Disability Access Report for SEPP Seniors Housing - Hostel

Project name
Jubilee

Location
20 Jubilee Ave, Mullumbimby NSW 2482

Stage
RFI's during DA application

Figure 2 - Screenshot of Ground Plan from DFT Design, shows three (3) Seniors living hostel units on the ground floor.

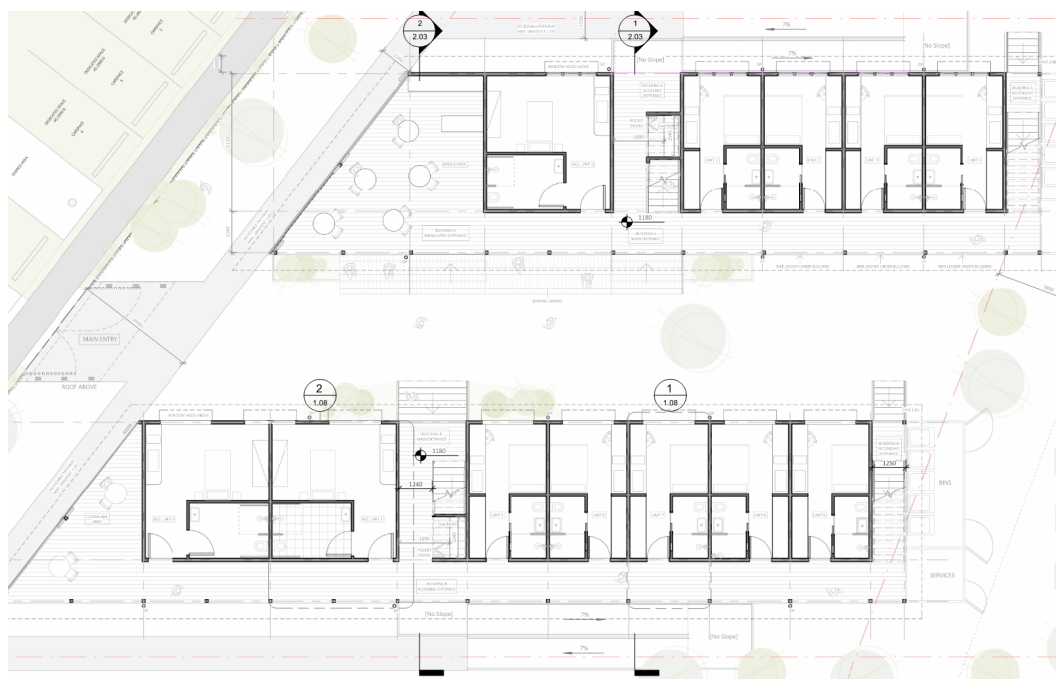
Under the BCA, a minimum of two units are required to be accessible, and the Byron Shire DCP requires 10% of units to be adaptable. This proposal includes three accessible units, which also serve as Seniors Living Hostel units, therefore exceeding the minimum requirements. The proposed Seniors Living development comprises one unit type/layout across the site.

- Provision of a lift to the first floor to meet Section 2 Siting standards (1) wheelchair access, in Schedule 4 of the SEPP (Housing) 2021.

Figure 2 - Acc. Unit 1 Building A

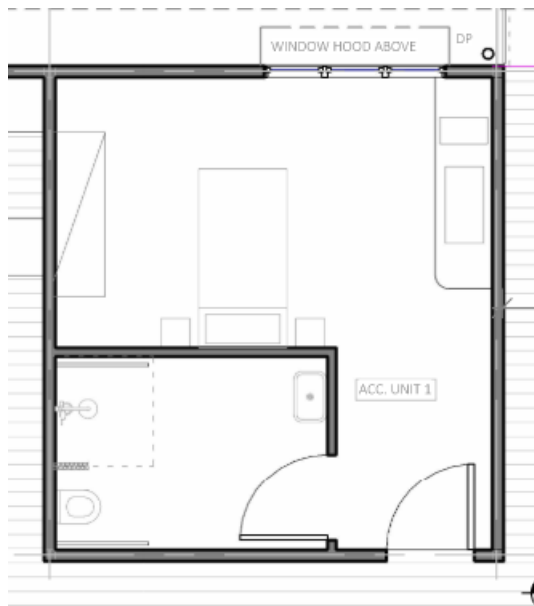
Three hostel units have been designed to comply with the accessibility and usability provisions of SEPP (Housing) 2021 – Schedule 4, Part 1: Standards Concerning Accessibility and Usability for Hostels and Independent Living Units.

Ground Level, Building A – Accessible Unit 1

Ground Level, Building B – Accessible Unit 2

Ground Level, Building B – Accessible Unit 3

In my professional opinion, this development has the capacity to satisfy the Seniors Living Hostel Unit design requirements for three accessible units, as outlined below:

Drawings – Layouts are consistent with the requirements of **SEPP (Housing) 2021 – Schedule 4, Part 1** for Seniors Housing.

Accessible Entry – Each accessible unit provides a **minimum 850 mm clear door opening** at the principal entry.

- Minimum doorway width: **850 mm**
Internal corridors: **minimum 1000 mm wide**
- Compliant main bedroom circulation spaces and power outlet locations (GPOs) (to be detailed at CC)
- Accessible bathrooms and toilets designed in accordance with **AS 1428.1:2021** (to be detailed at CC)
- Non-slip floor coverings to balconies and external paved areas (to be detailed at CC)
- Door hardware positioned between **900 mm and 1100 mm** above floor level (to be detailed at CC)
- Light switches and power points positioned for accessibility (to be detailed at CC)

Figure 14, Screenshot of proposed car parking proposed

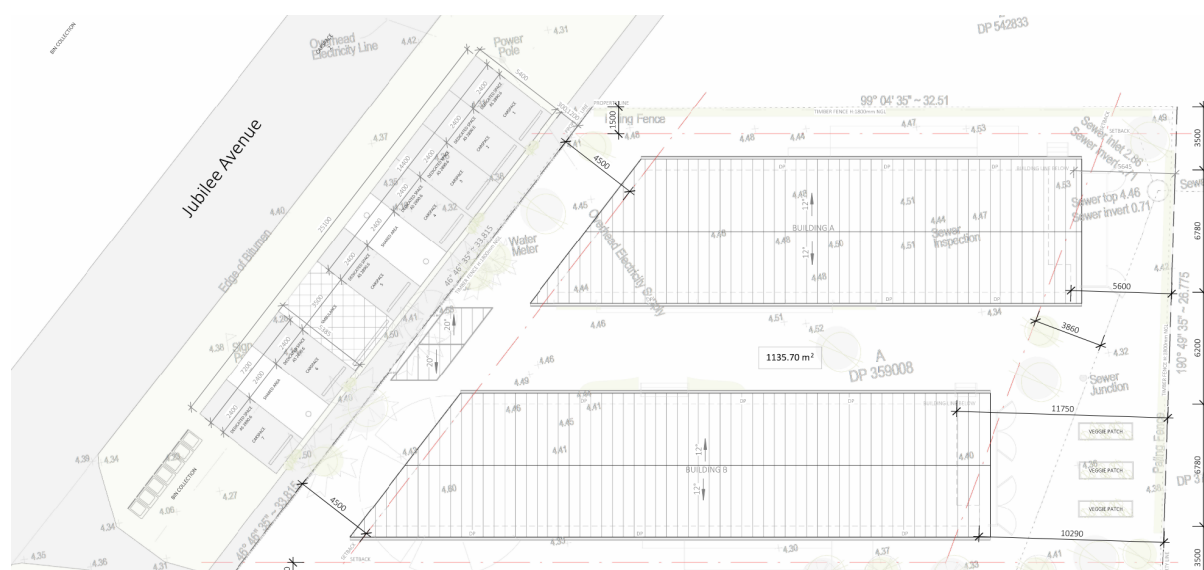
A total of seven (7) car parking spaces are proposed within the kerbside car park.

Of these, four (4) car parking spaces comply with the spatial requirements of **AS 2890.6:2009 – Off-Street Parking for People with Disabilities**.

In accordance with Clause (2)(b)(ii) of Schedule 4 – Standards Concerning Accessibility and Usability for Hostels and Independent Living Units under SEPP (Housing) 2021, at least 50% of car parking spaces are required to comply with AS 2890.6.

The remaining car spaces have standard widths of 2400 mm.
